Re: Preliminary Draft Mound Basin Groundwater Sustainability Plan (July 2021)

The revised Draft GSP should be re-circulated to give NMFS, and other interested parties, an opportunity to review the revisions before the Draft GSP is finalized.

Figure 1. Lower Santa Clara River and Santa Clara River Estuary Steelhead Critical Habitat within the Mound Groundwater Basin.

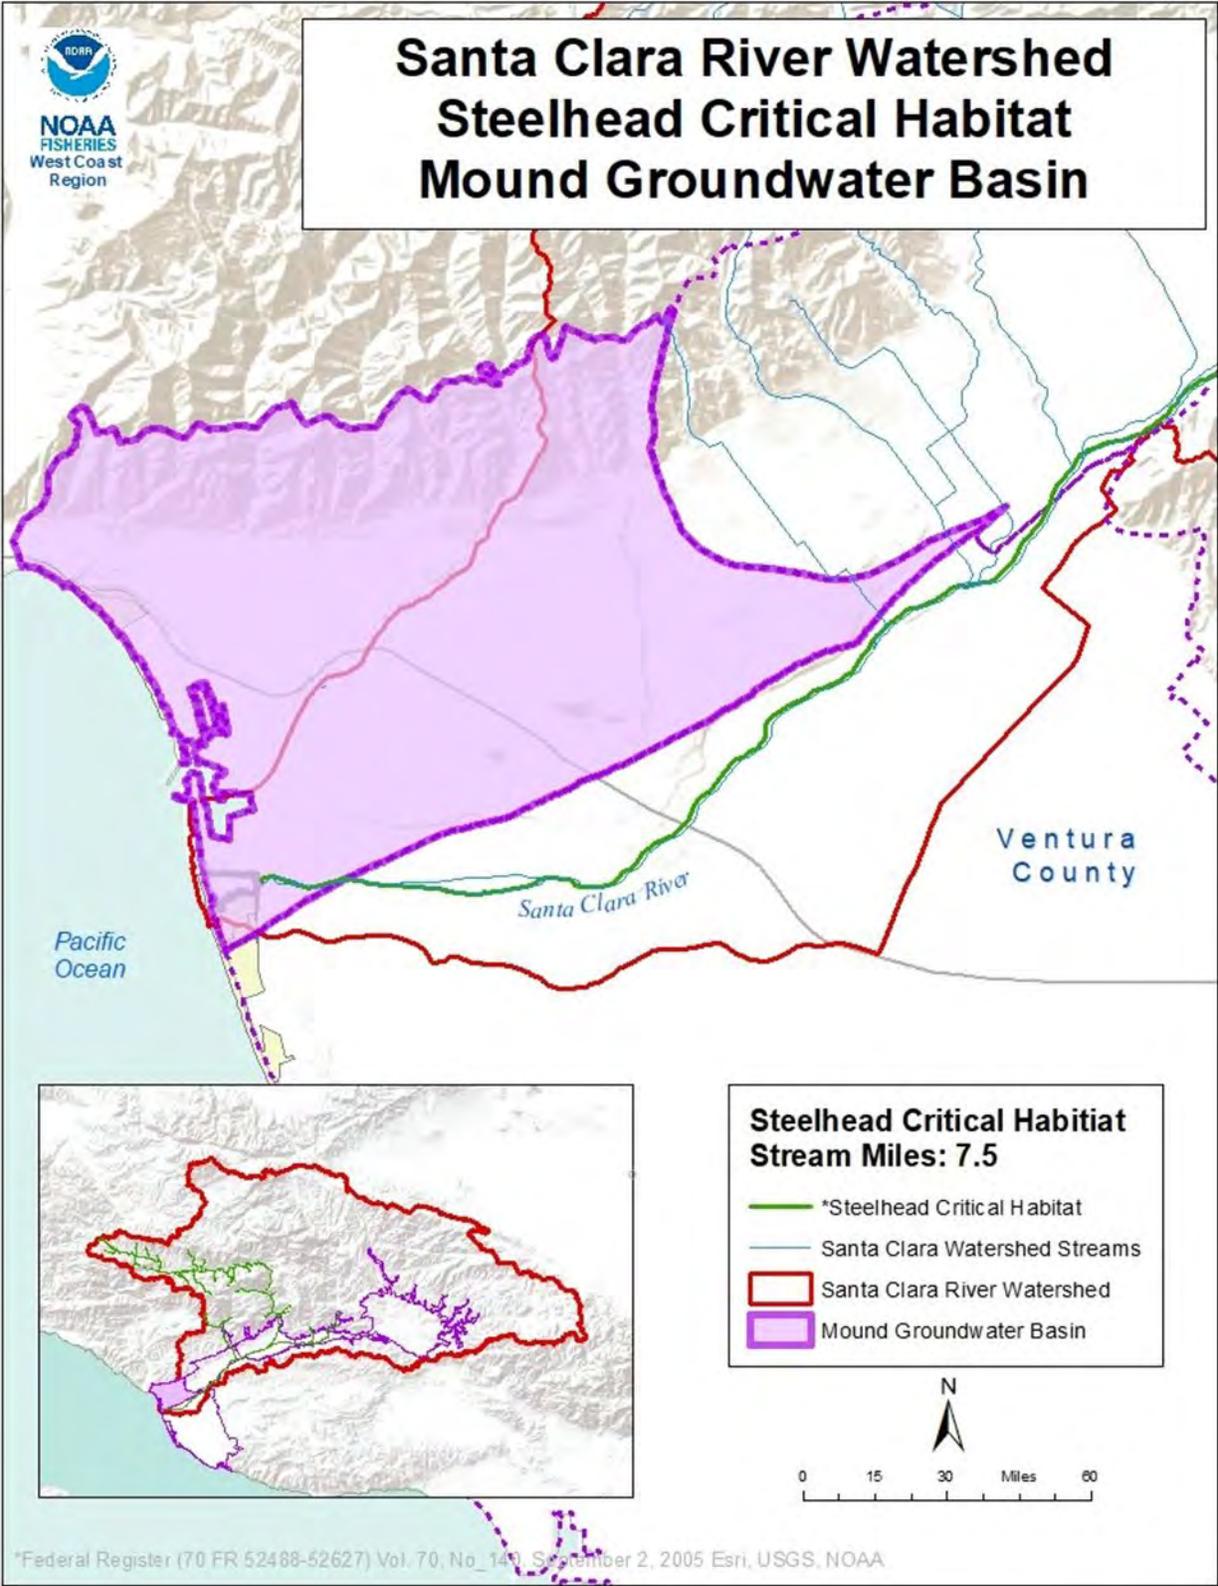
Specifically, the revised Draft GSP should include a description of the extent of designated critical habitat for endangered steelhead (as well as other listed or recognized sensitive species) that occur within the boundaries of the Mound Basin (*See* Figures 1 and 3).

Figure G-5. Hydrogeological Cross Section F-F' from Hopkins, 2018, Showing Detailed Stratigraphy Below the Santa Clara River in Mound Basin (Plate 10 in Hopkins, 2018, report).

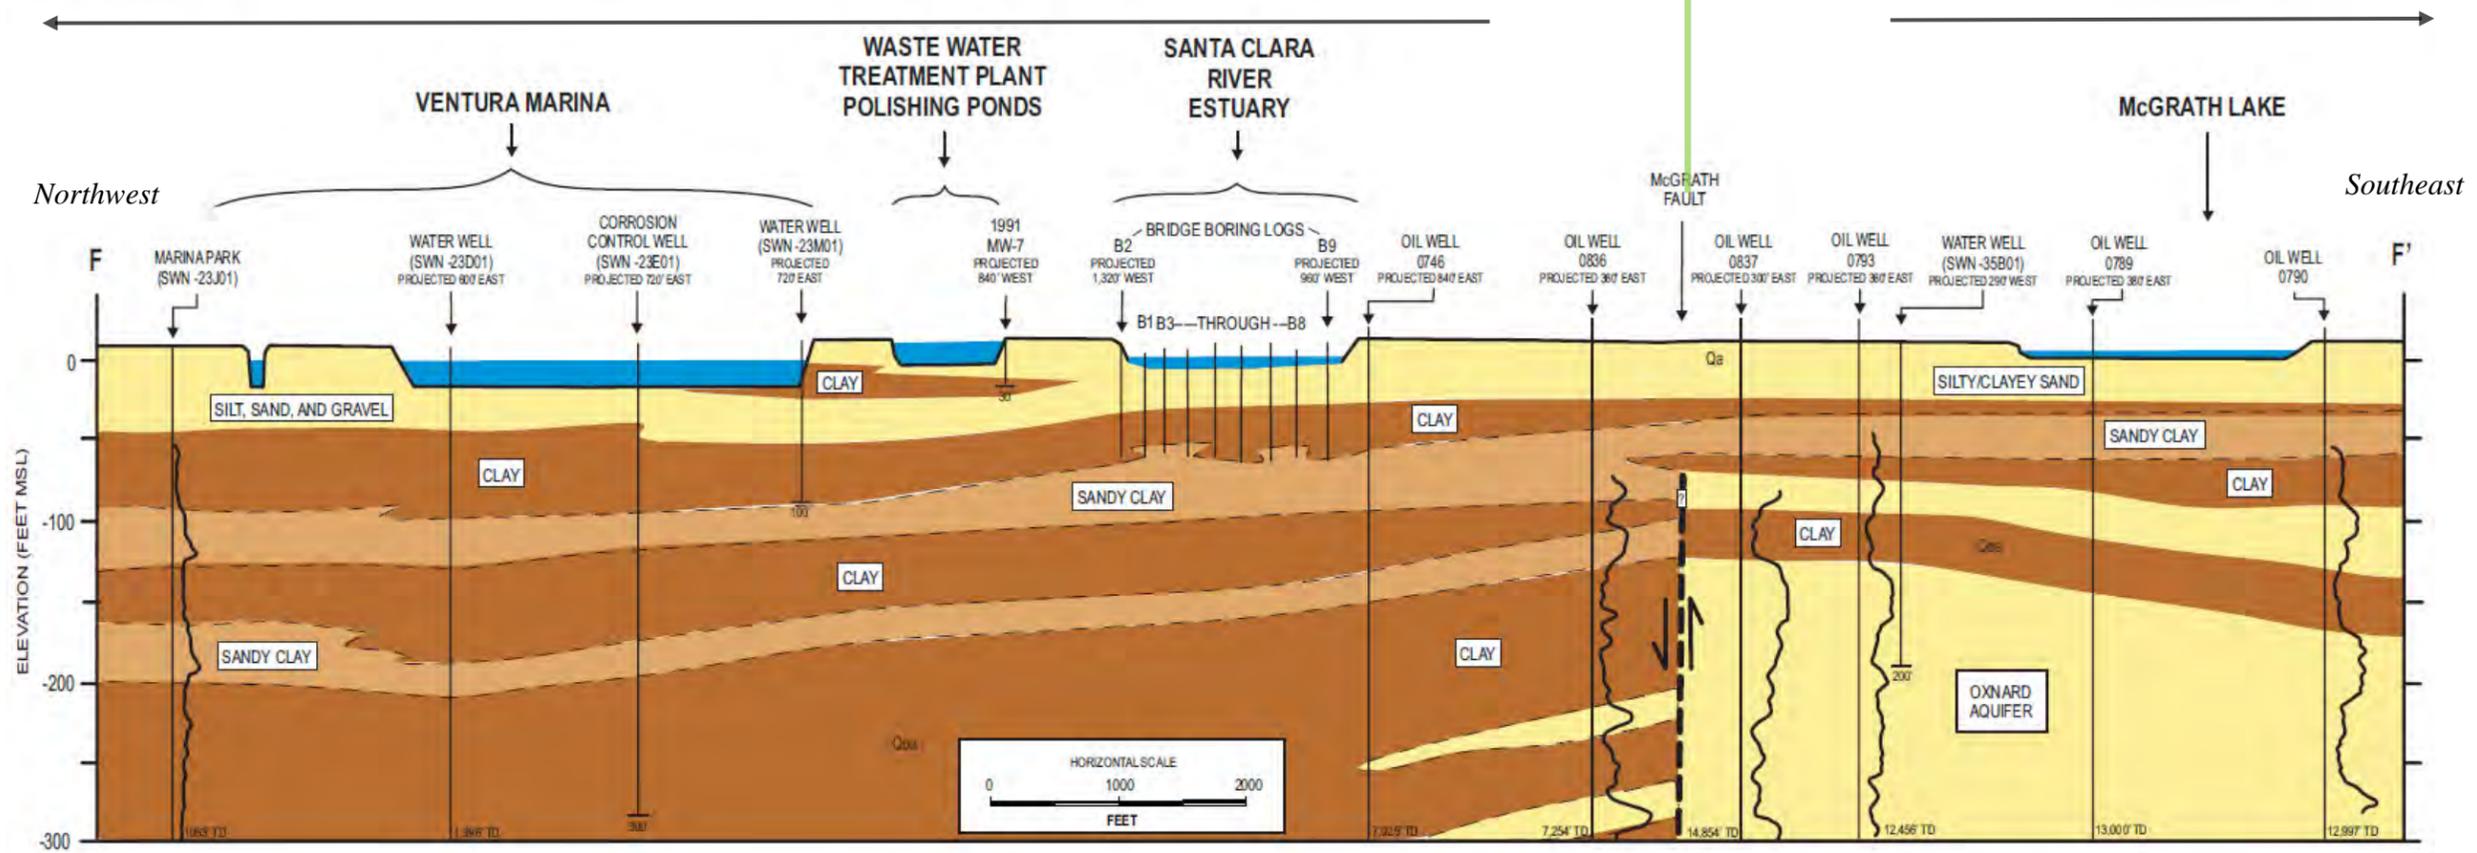
For reference, cross-section D-D' from the GSP, included herein as Figure G-6, depicts the depths of the HSUs in Mound Basin under the Santa Clara River and its estuary, but with less detail than shown on cross-section F-F'. From cross-section D-D', it can be seen that the Hueneme and Fox Canyon aquifers are further disconnected from the Shallow Alluvial Deposits (compared to the Mugu Aquifer) by a maximum of 2,000 feet of vertical separation and additional aquitards. Importantly, most of the groundwater extraction in the Mound Basin is by wells screened in the Hueneme Aquifer, which is separated from the Shallow Alluvial Deposits and Santa Clara River by two aquitards that are approximately 300 to 400 feet in total thickness.

Figure G-7. Groundwater Elevations Reported for Selected Wells and Shallow Piezometers near Santa Clara River in Mound Basin, 2009-17, and Total Groundwater Extracted from Mound and Oxnard Basins

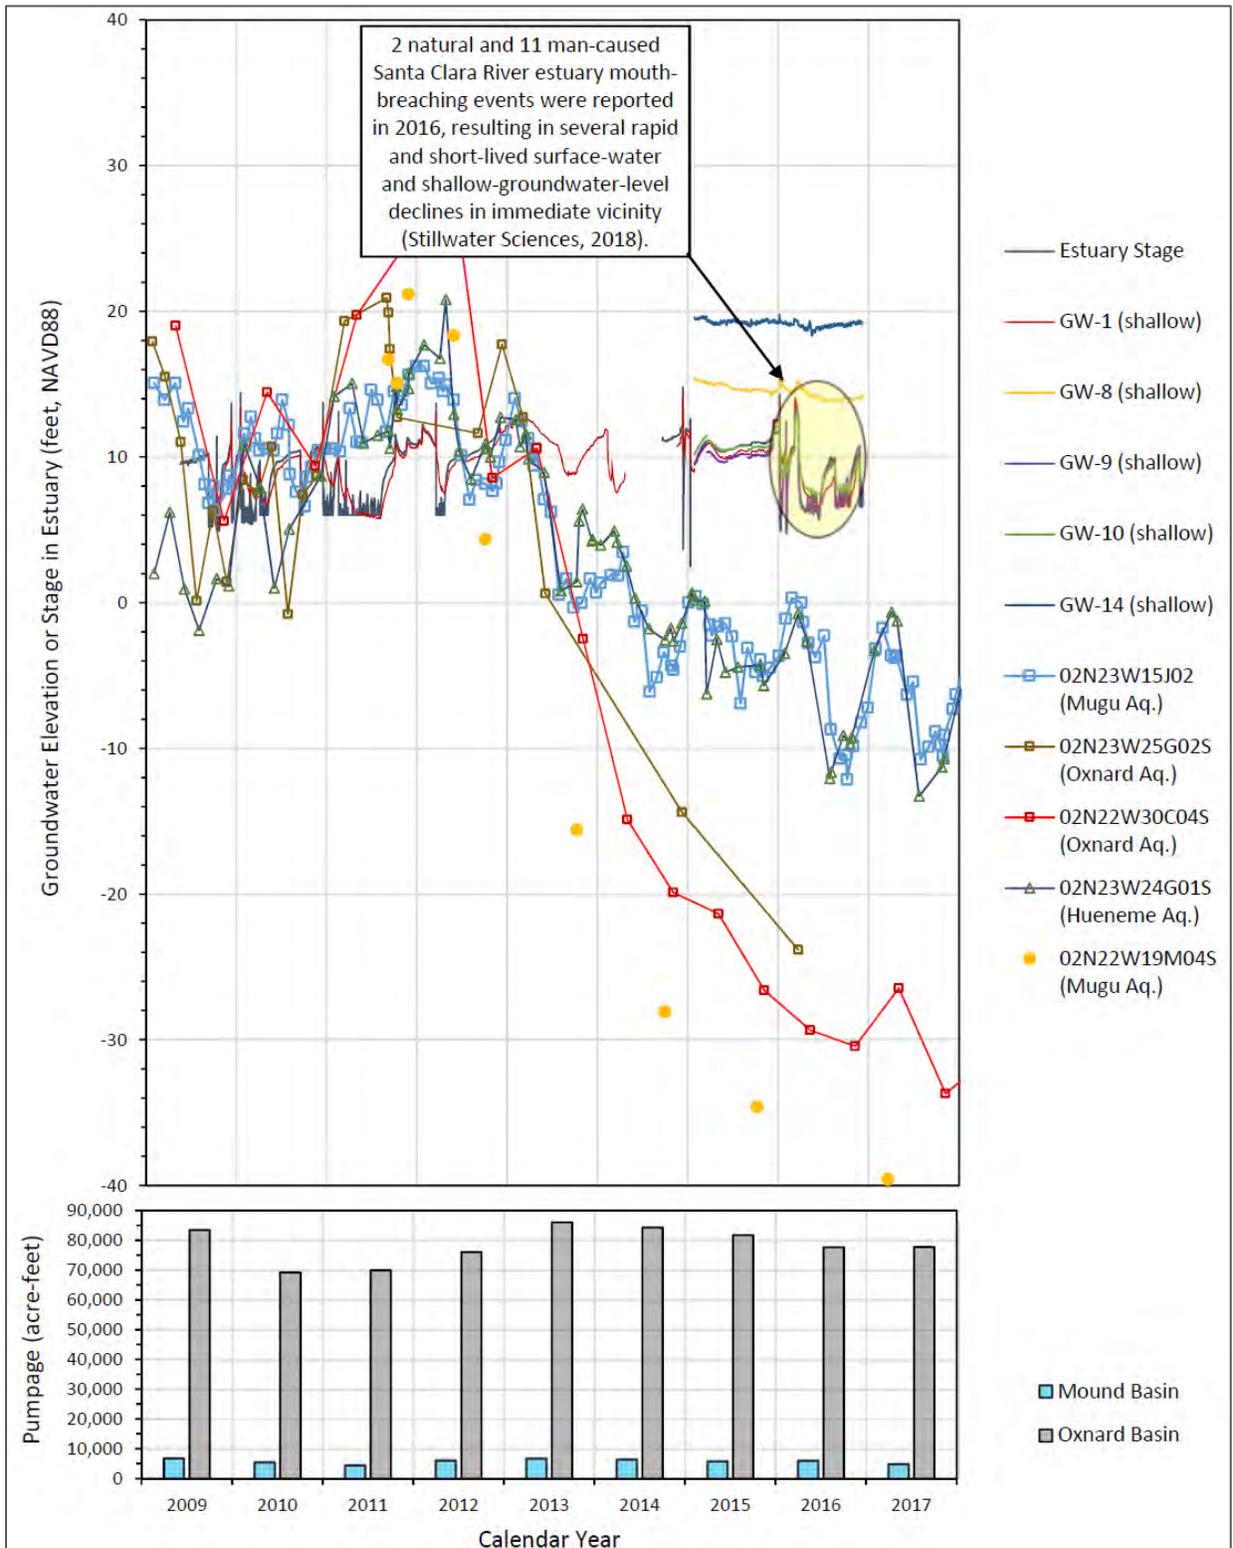
Review of available groundwater elevation data for piezometers screened in the Shallow Alluvial Deposits and in wells screened in the principal aquifers in Mound Basin confirm that there is no discernible effect of groundwater-level declines in the principal aquifers on shallow-alluvial groundwater levels during the recent (2012-16) drought. Figure G-7 shows significant declines (up to 50 feet) in measured groundwater elevations at wells screened in the Mugu and Hueneme Aquifers in Mound Basin near the Santa Clara River during the 2012-2016 drought, while groundwater elevations in the piezometers screened in shallow alluvial or stream terrace deposits adjacent to and underlying the Santa Clara River estuary remain relatively constant near 10 feet relative to the 1988 North American vertical datum (NAVD88), with occasional sharp departures and returns from that base elevation in response to river-mouth breaching events. Locations for these wells are shown on Figure G-1. Total groundwater extractions from the Mound and Oxnard basins are also shown on Figure G-7, for reference. As shown on Figure 3.1-26 of the Draft GSP (included herein as Figure G-8), there is just one active water supply well screened in the Mugu Aquifer, and one active water supply well with an unknown screened interval, located within 1 mile of the reach of the Santa Clara River within Mound Basin. A total of 155 AF of groundwater was extracted from the Mugu Aquifer well (02N22W19M04S) in 2019 and a total of 2 AF was extracted from the unknown-screened-interval well (02N23W24F01S) during 2019, as summarized in Table 3.1-02 of the Draft GSP. Two Hueneme Aquifer wells are also located within 1 mile of the Santa Clara River in Mound Basin, but as noted above, the Hueneme Aquifer is hydraulically disconnected from the Shallow Alluvial Deposits (and Santa Clara River) not just by the fine-grained Pleistocene deposits, but also by the Mugu Aquifer and the Mugu-Hueneme aquitard. Indeed, there is no relationship between groundwater extraction in Mound or Oxnard Basins and groundwater elevations measured in the piezometers screened in the Shallow Alluvial Deposits in Mound Basin that can be discerned in Figure G-7.

Figure G-9. Volume of Simulated Groundwater Exchange with Surface Water along Santa Clara River in Mound Basin in Base Case and Sensitivity Runs

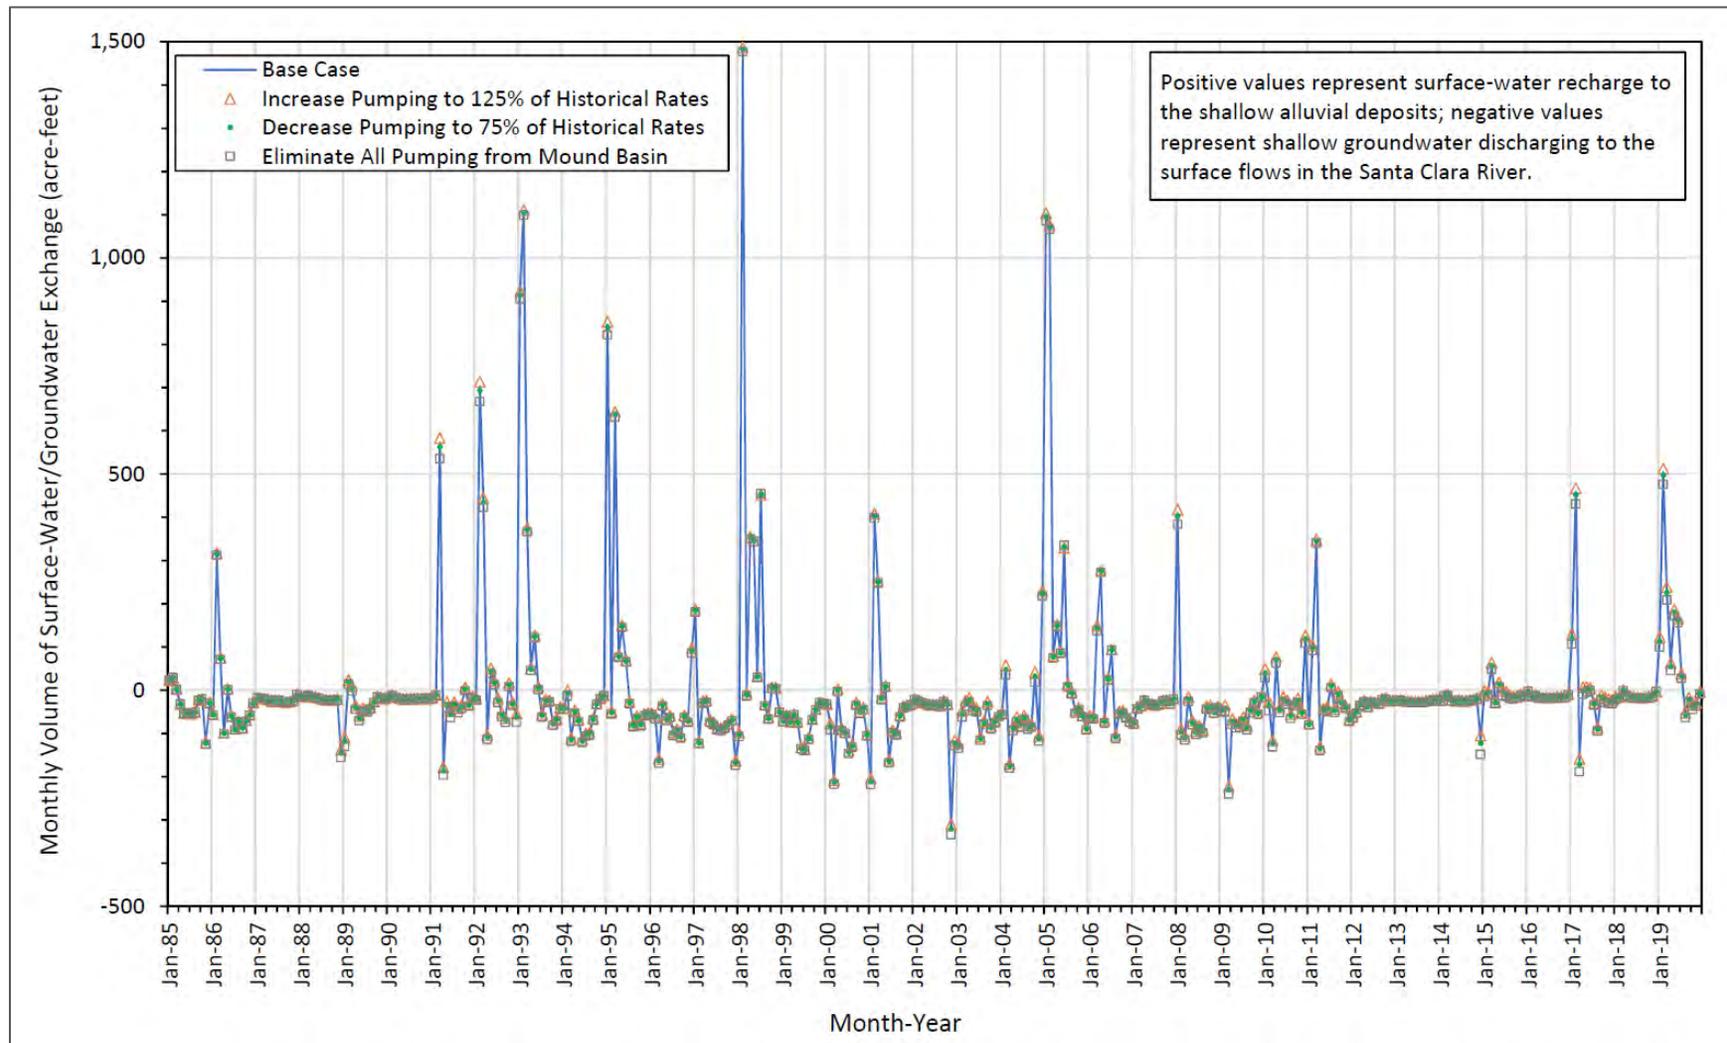
The differences in groundwater discharge to surface water under all three sensitivity runs are nearly identical to the base case (Figure G-9), suggesting that groundwater extraction in the principal aquifers has a negligible influence on groundwater levels in the Shallow Alluvial Deposits and flows in the Santa Clara River. The differences between average groundwater discharge to surface water throughout the modeled period (1985-2019) in the base case versus the sensitivity runs that assume 75 and 125 percent of historical groundwater extraction range from 15 AF/yr more to 15 AF/yr less than the base case values, respectively (15 AF/yr is equal to 0.02 cfs). As noted in Section 2.3 of this appendix, these values are a very small fraction of the total flow in the lower reach of the Santa Clara River, which ranges from 1 to 750 cfs (Stillwater Sciences, 2018). In the sensitivity run where no groundwater is extracted from Mound Basin, simulated groundwater discharge to surface water increases by 61 AF/yr (0.08 cfs), which again is a very small fraction of total flow in the lower reach of the river. The small change in simulated surface water flows demonstrates that groundwater conditions in the principal aquifers (Mugu and Hueneme aquifers), including groundwater extraction, do not materially influence surface water flows, consistent with the data summarized in preceding sections of this appendix.

Figure G-10. Graphs Showing Differences Between Simulated Groundwater Elevations in Shallow Alluvial Deposits in Base-Case Scenario Compared to Sensitivity Runs under Santa Clara River estuary (top graph) and under Santa Clara River near Boundary between Mound and Oxnard Basins (bottom graph)

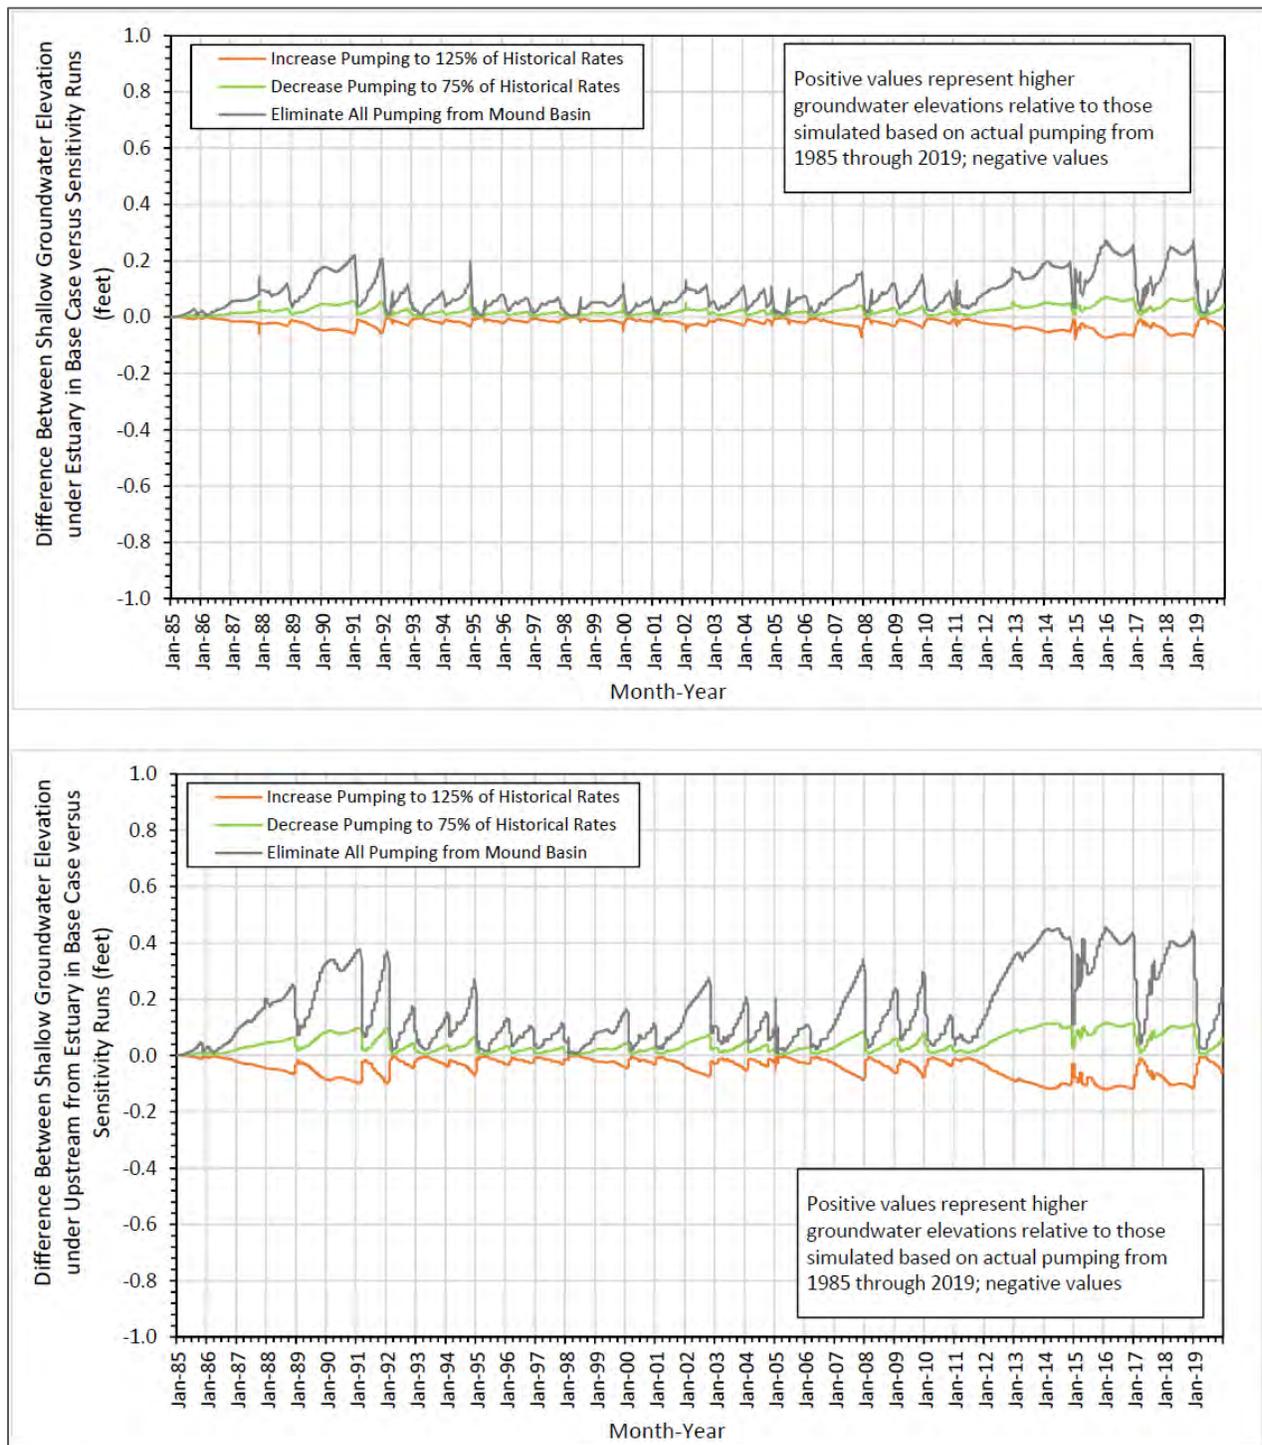
The differences in groundwater elevations for the sensitivity runs compared to the base case are mostly less than 0.1 feet, except for the no-pumping sensitivity run, as shown on Figure G-10. The locations where these differences in groundwater elevations were calculated are shown on Figure G-11. In the no-pumping sensitivity run, simulated groundwater elevations in the Shallow Alluvial Deposits increase 0.2 to 0.4 feet compared to the base case. The small change in simulated shallow groundwater levels demonstrates that groundwater conditions in the principal aquifers (Mugu and Hueneme aquifers), including groundwater extraction, do not materially influence groundwater conditions in the Shallow Alluvial Deposits. The model estimated groundwater elevation changes are considered negligible and additionally are conservative because the United (2021) model may overestimate the degree of hydraulic connection between the saturated sediments in contact with the Santa Clara River and the deeper principal aquifers in Mound Basin. This is because the model uses a single layer to represent the entire thickness of the Shallow Alluvial Deposits, and therefore, the model assumes instantaneous and direct responses occur throughout Layer 1 (from land surface to the base of the Shallow Alluvial Deposits) to changes in extraction rates and recharge in deeper layers or HSUs. The Shallow Alluvial Deposits actually consist of multiple layers and
